In the United States Patent and Trademark Office

For: Self-Route Expandable Multi-Memory Packet Switch with Distributed Scheduling Means

Serial Number: 09/683,429

Response and Amendment Under 37 C.F.R. §1.111
And Petition for One Month Extension of Time Under 37 CFR 1.136(a)(1)

FIG. 3

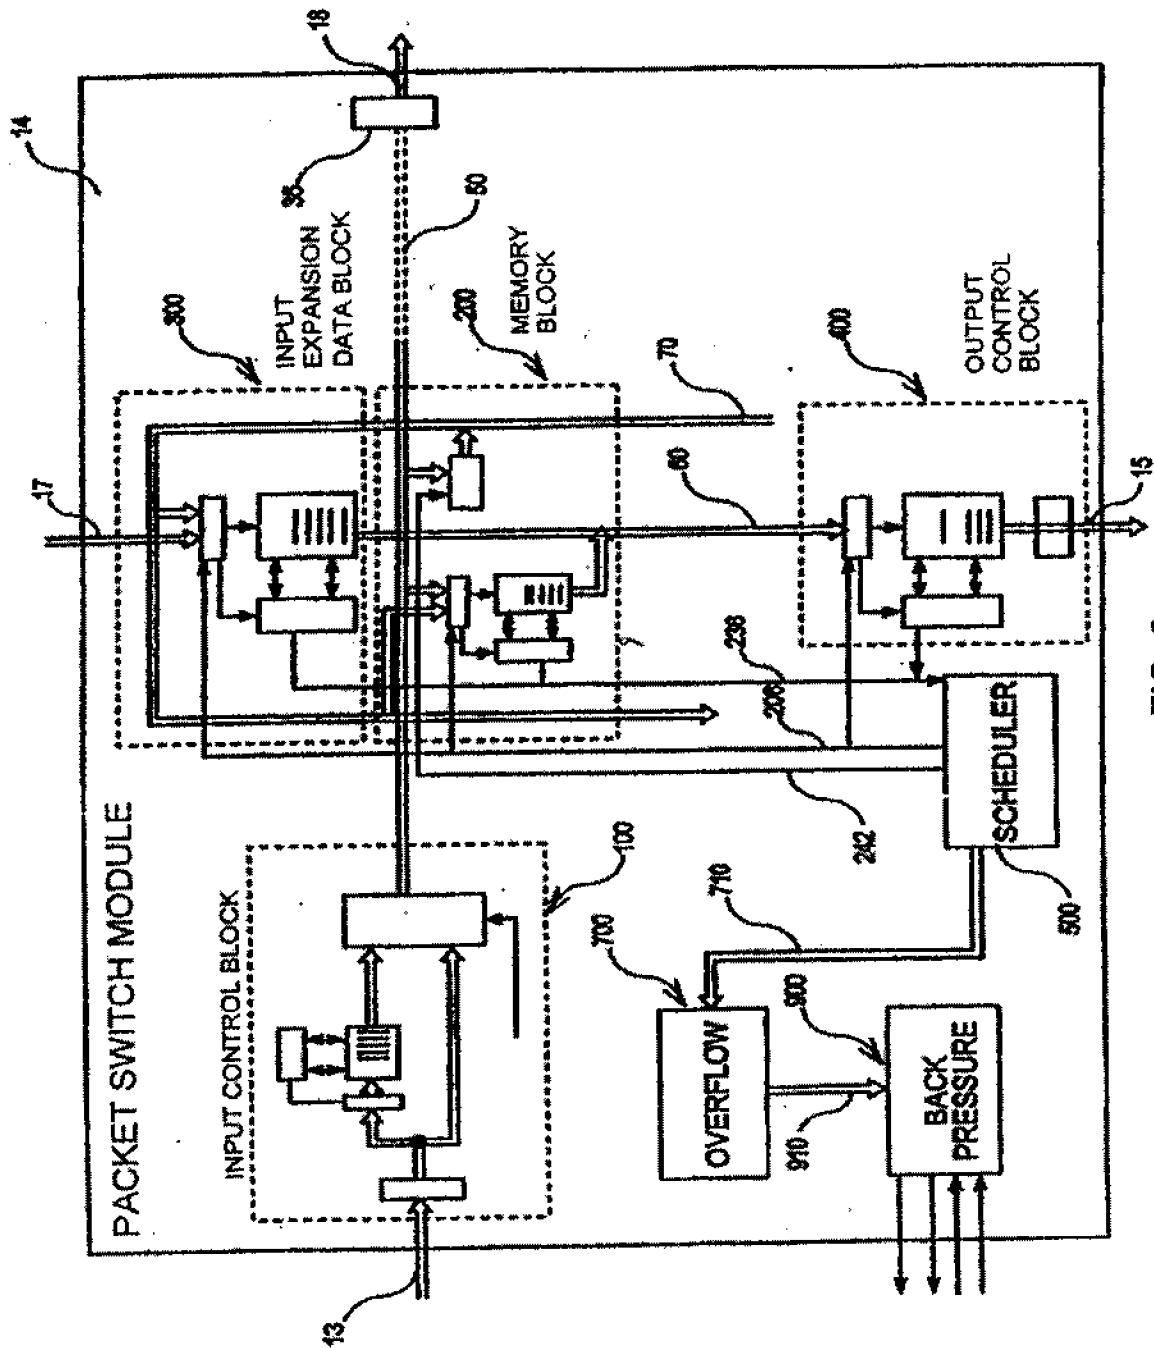
The Office Action stated an objection to Figures 3-8 as failing to comply with 37 CFR 1.121(d) because descriptive labels necessary for understanding the drawings are missing. The Office Action also stated that the quality of the connections shown on Figure 8 is not acceptable. A proposed set of drawings to overcome the objections is attached to this amendment as Appendix A. Each sheet has been labeled "Replacement Sheet" to be in compliance with 37 CFR 1.121(d).

The Office Action stated that claims 1-14 are rejected under 35 U.S.C. 112, second paragraph as being indefinite for failing to particularly point out and distinctly claim the subject matter which applicant regards as his invention. Specifically, for Claim 1, the Office Action stated that it was unclear as to what output and input ports are considered a pair and what is the definition of a cross point. Applicants submit that the definition of “cross point” is defined in paragraph 10 of the specification as “each couple of an input port and an output port defining a cross point within the switch module” and is shown in Figures 1, 3, 5, and 8. In Figure 1, the input and output ports are shown as the input buses 13_1 – 13_4 and corresponding output busses 15_1 – 15_4 coupled

to the packet switch module 14. A pair is therefore any one of the input ports (i.e. input bus 13) coupled to any one of the output ports (i.e. output bus 15). For example, one cross point is input bus 13_1 coupled to output bus 15_4, or input bus 13_2 coupled to output bus 15_3, etc. Thus, for 4 input ports and 4 output ports there is a total of 16 cross points. In Figure 3 the cross point is shown as the intersection of elements 50 and 60, which are coupled to data bus in 13 and data bus out 15 respectively (see paragraph 27). Memory Block 200 is associated with the cross point shown in Figure 3. Figure 5 shows a block diagram of Memory Block 200 with the intersection of elements 50 and 60 showing the cross point. Figure 8 shows multiple cross points for input ports 13_1 – 13_m and output ports 15_1 – 15_m and represents an mxm number of cross points with associated memory blocks 200 for each cross point.

each memory block associated with one of said cross points ...”. Support for Applicants’ claim 1, as amended, can be found, for example, in paragraph 0025 and Figure 3.

FIG. 8

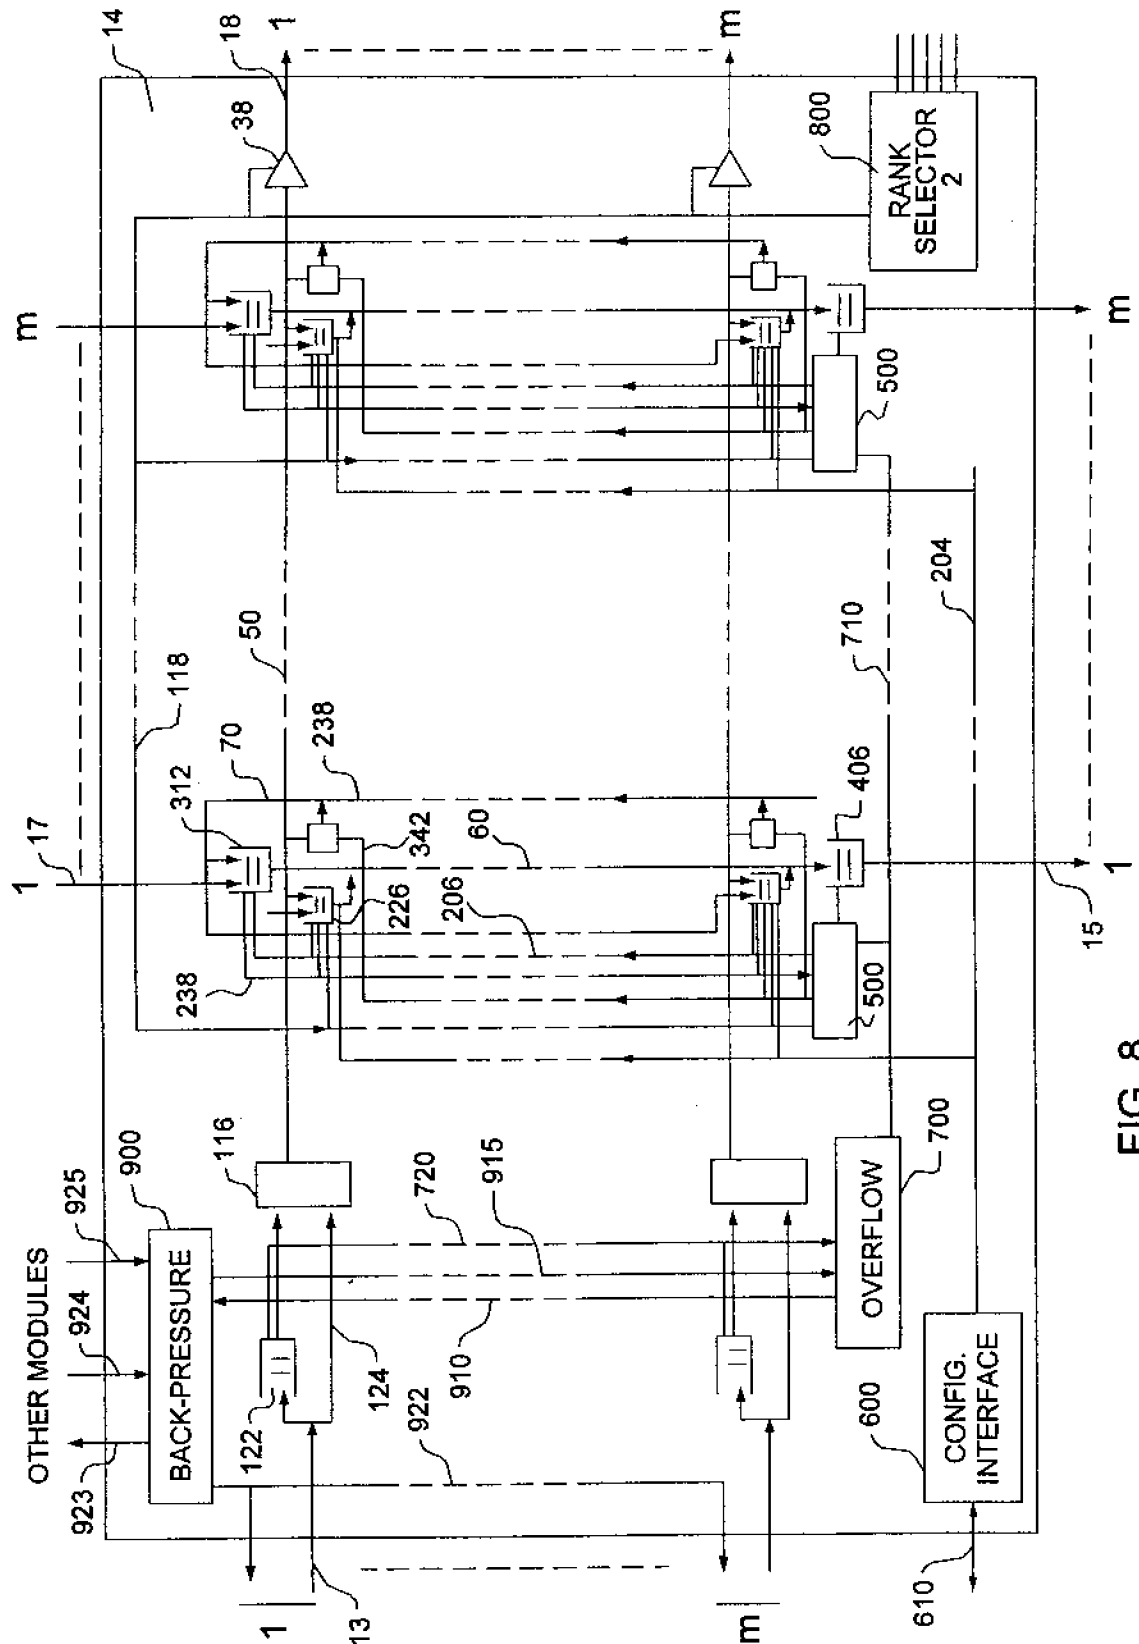
Applicants respectfully submit that Yamazaki does not teach or suggest the limitation of Applicants’ claim 1, as amended, of “...a plurality of schedulers, each scheduler associated with one of said output ports ...”. Support for Applicants’ claim 1, as amended, can be found, for example, in paragraphs 0008, 0026, 0051, 0052 and Figures 3 and 8.
